Response to Comments

City of Los Angeles
Terminal Island Water Reclamation Plant (TIWRP)
Tentative NPDES Permit

This Table describes all significant comments received from interested persons with regard to the above-mentioned tentative permit. Each comment has a corresponding response and action taken.

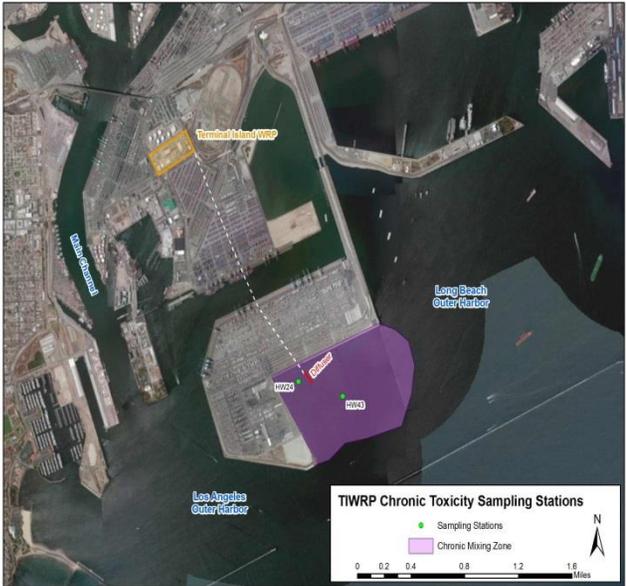
Commenter	#	Comment	Response	Action Taken
			section 136.5.	
	21	Section VIII.J., pg. 29. Typo The closing parentheses are missing.	Staff agreed.	Revisions were made to the permit
	22	<p>Section VIII.O., pg. 31. <u>Include Bioaccumulation Equivalency Factors (BEFs) for calculation of 2, 3, 7, 8-TCDD equivalents.</u> The current approach for calculating 2, 3, 7, 8-TCDD equivalents involves use of toxicity equivalency factors (TEFs) that are applied to each of the 17 dioxin congeners. Just as the different dioxin congeners exhibit different levels of toxicity, they also exhibit different levels of bioaccumulation potential. To account for the different levels of bioaccumulation potential, each congener may also be assigned a bioaccumulation equivalency factor (BEFs). BEFs correspond to the differences in biological uptake from the water column through the food web for the various dioxin congeners. The BEFs were developed under the Great Lakes Water Quality Initiative and are currently utilized by the San Francisco Bay Regional Water Board to assess Reasonable Potential and evaluate permit compliance. The City requests the following changes:</p> $Dioxin\ Concentration = \sum_{i=1}^{17} (C_i)(TEF_i)(BEF_i) = \sum_{i=1}^{17} (TEQ_i)$ <p>Where:</p>	<p>BEFs are not used in the State Implementation Policy and the use of BEFs has not been approved by USEPA since site-specific BEFs are not available. The only NPDES permit in Region 4 that incorporated BEFs into the calculation of the TEQs is the Boeing permit Order No. R4-2010-0090. BEFs were only approved for this permit because of the naturally occurring dioxin congeners in stormwater due to fires that occurred on the Santa Susana property. The site-specific BEFs used in the Boeing permit are from the Great Lakes region and are not applicable in California. Since these site-specific BEFs cannot be applied to Terminal Island and there are no site-specific BEFs for the Los Angeles Harbor, BEFs cannot be applied to this Order at this time.</p>	None necessary
